REMARKS

In the Drawings:

Redlined Drawings

FIG. 1D

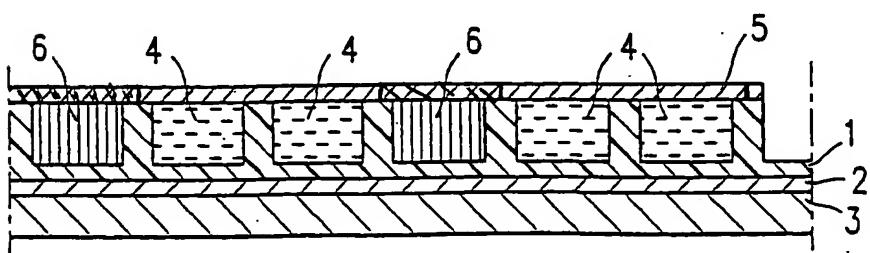
In the original drawings, the same graphic pattern was used in Figures 1D-1H for two different features (the photoresist and the sealing layer). To avoid confusion, Applicant has amended the drawings to have two different graphic patterns representing the photoresist and the sealing layer. Support for the amendment can be found throughout the application describing the photoresist and the sealing layer.
